**SUBJECT: JOSEPH M. FARLEY NUCLEAR PLANT, UNITS 1 AND 2, ISSUANCE
OF AMENDMENT NOS. 261 AND 258, TO REVISE TECHNICAL
SPECIFICATION 3.3.1 AND 3.3.2 ALLOWABLE VALUES
(EPID L-2025-LLA-0145)**

SAFETY EVALUATION BY THE OFFICE OF NUCLEAR REACTOR REGULATION

JOSEPH M. FARLEY NUCLEAR PLANT, UNITS 1 AND 2

The proposed amendments would revise selected Allowable Values (AVs) in Technical Specification (TS) 3.3.1, "Reactor Trip System (RTS) Instrumentation" and TS 3.3.2, "Engineered Safety Feature Actuation System (ESFAS) Instrumentation."

Figure 4-1
Farley Nuclear Plant Setpoint Error and Margin Diagram
(for increasing parameter function)

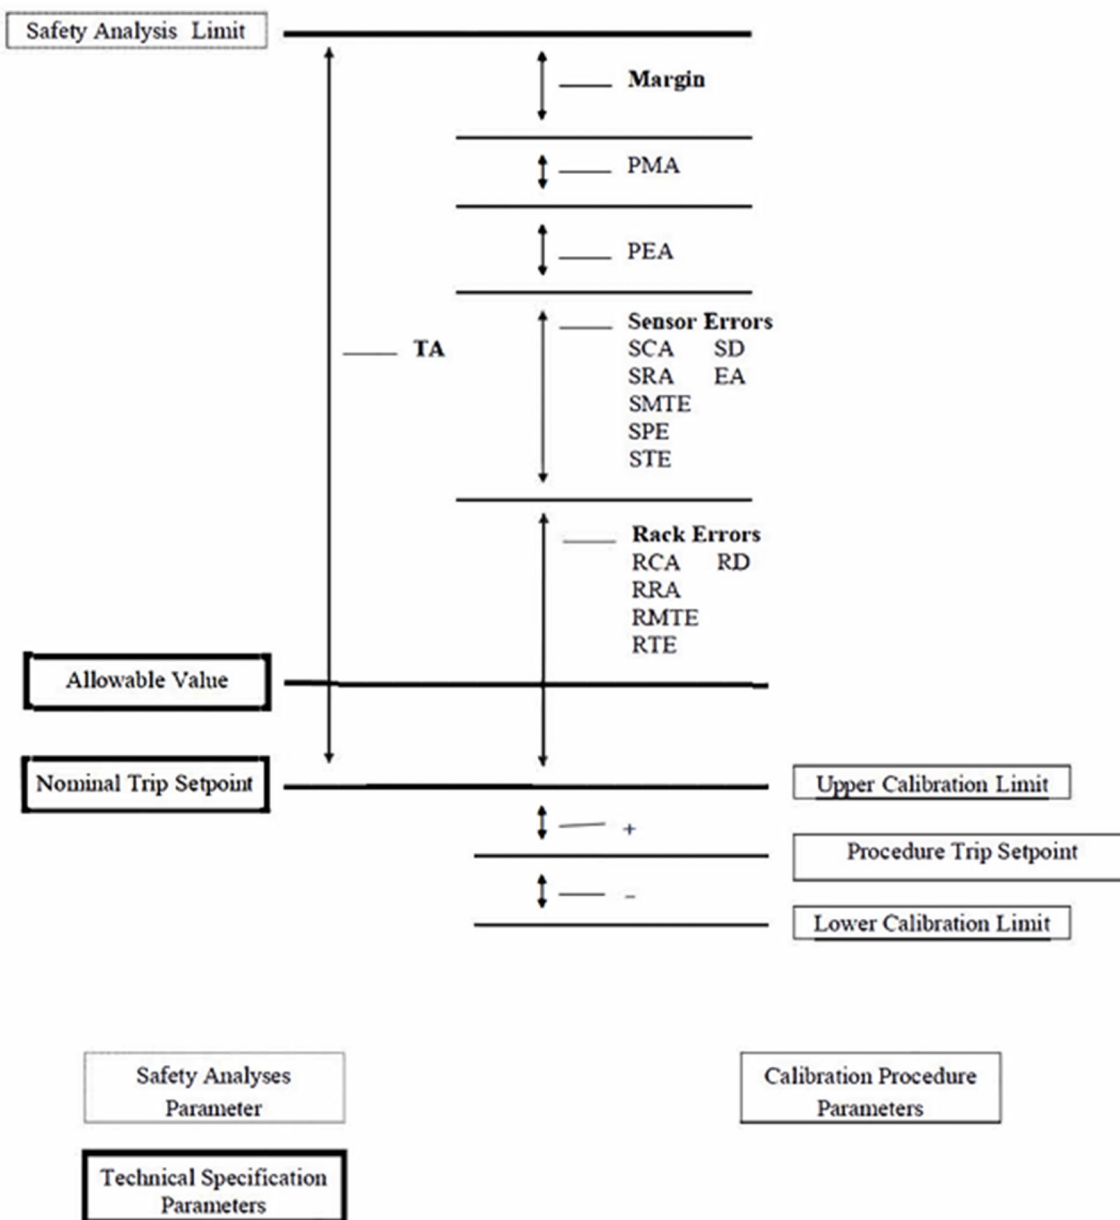
In Revision 7 of WCAP-13751-P, the licensee notes that Revision 6 of WCAP-13751-P, complies with TSTF-355, which sets the actual trip setpoint to be more conservative than the defined NTS in the TS. Visual representations of the conservative trip setpoint (Labeled as "Procedure Trip Setpoint" [PTS]) are shown in figures 4-1 and 4-2 of WCAP-13751-P.

The licensee's methodology follows an arithmetic summation method, which considers the uncertainty allowance of the RCA and RD in reference to the actual trip setpoint Upper Calibration Limit (UCL). The licensee states its calibration tolerance has been reduced to a value that bounds its expected RD for an operable instrument channel. This results in an expectation where the AV is limited to the RD calculated from the Lower Calibration Limit (LCL) of the PTS.

The NRC staff determined that if the licensee maintains its proposed settings at the PTS, the values proposed for the AVs would be more conservative than those described as the nonconservative direction of the “as-found tolerance” depicted in figure 1 of ANSI/ISA 67.04.012018.

The NRC staff notes that, in reviewing certain TS-controlled calculated instrument channel uncertainties in WCAP-13751-P, the methodology for determining AVs is as defined in the AV formula above. Through the use of this methodology, it is mathematically possible for an instrument channel’s “as found” measured value to be within the calculated drift allowance yet beyond the TS controlled instrument channel’s AV.
